Subject: **Technical Comments on the Work Plan and Cost Estimates of Old Raleigh LF #4 Task Orders 687DP-1&2**

===== Technical Review Comments =====

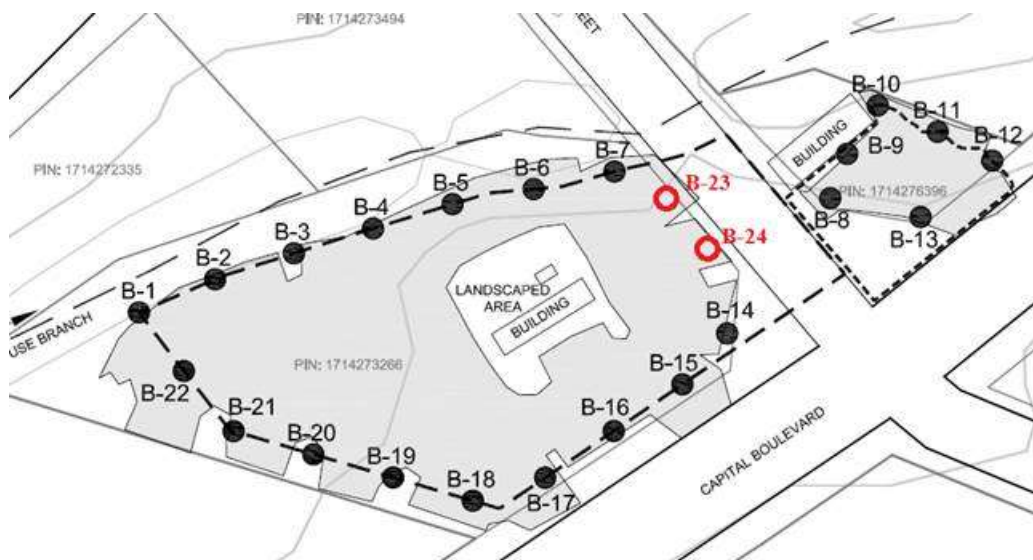
1). Work Plan, Section 2, Sub-Section 2.1: Add two more soil bores (see the approximate locations B-23 and B-24 in map below). Reflect the additions in the final Work Plan & Cost Estimates accordingly.
